UNITED STATES PATENT AND TRADEMARK OFFICE

APPLICATION NO.	FILING DATE	FIRST NAMED INVENTOR	ATTORNEY DOCKET NO.	CONFIRMATION NO.
10/774,272	02/06/2004	Christoph Andreas Roth	008932-0876-999	8488
51832	7590	11/01/2005		
JONES DAY 222 EAST 41ST STREET NEW YORK, NY 10017-6702			EXAMINER SWIGER III, JAMES L	
			ART UNIT 3733	PAPER NUMBER

Office Action Summary	Application No. 10/774,272	Applicant(s) ROTH ET AL.	
	Examiner James L. Swiger	Art Unit 3733

DETAILED ACTION

Figure 1.

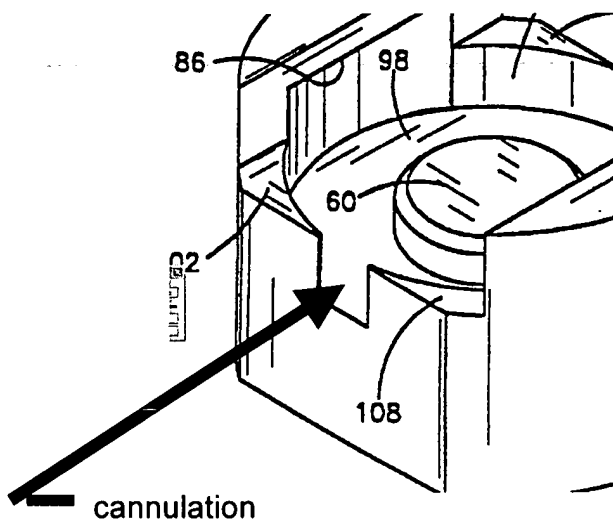
Claims 1-4, 6,9,10-12,13-19,20-22,30-32 are rejected under 35 U.S.C. 102(b) as being anticipated by Asher et al (U.S. Patent No. 5,257,993). Asher et al. discloses a device having a mechanism (Fig. 1) comprised of a body member (22), a single prong (28), and a drive member (60a). The device of Asher et al. is also capable of having a first and second engagement surface and is capable of a location within a longitudinal channel and tabs (68a and 70a). The disclosed device also has a bore area (32a), and a substantially cylindrical portion (26a). The device of Asher et al. also discloses a drive member that is rotatable (Col. 7, line 42) and functions with an end cap (24). Finally, Asher et al. discloses a cannulation for use in a guidewire (See Fig. 1 below).

Fig. 2

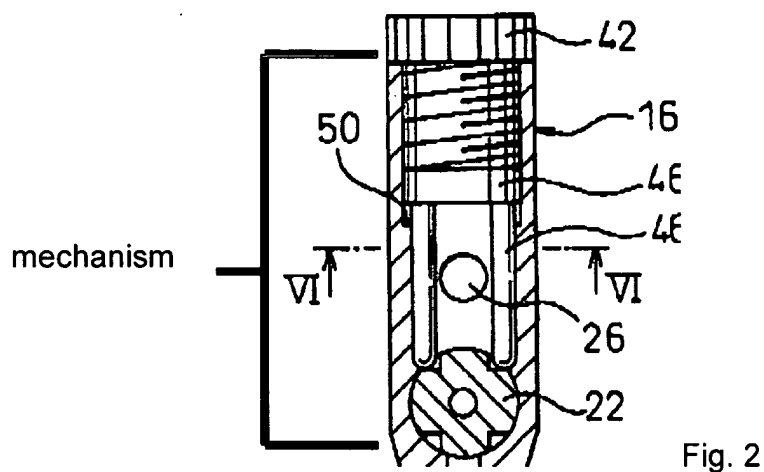
Claims 1-9,13-18 and 23-29,33-34 are rejected under 35 U.S.C. 102(e) as being anticipated by Fujiwara (U.S. Patent No. 6,406,477). For claims 1-9,13-18, Fujiwara discloses a device having a mechanism (See Fig. 2 below).

Fujiwara also discloses a device having a body member (46a), a single prong (46), drive member (40), a first and second engagement surface (Fig. 2), a longitudinal channel (16b), stops (34), a bore (26), a predetermined angle with the first longitudinal axis (see Fig. 3 below), a drive member (42) that is rotatable and threadably engages the first implant, and has an end cap (top section of 42).

Figure. 3

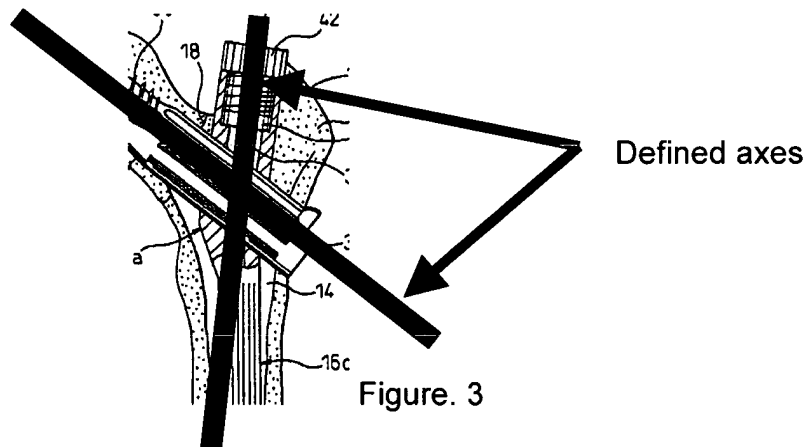
sliding of the second implant. The word "substantially" functions as an indefinite term in this situation, and is examined in the broadest reasonable interpretation. The mechanism also extends through a bore in the first implant at the intersection of the axes in Fig. 3, and an end cap (top of 42).
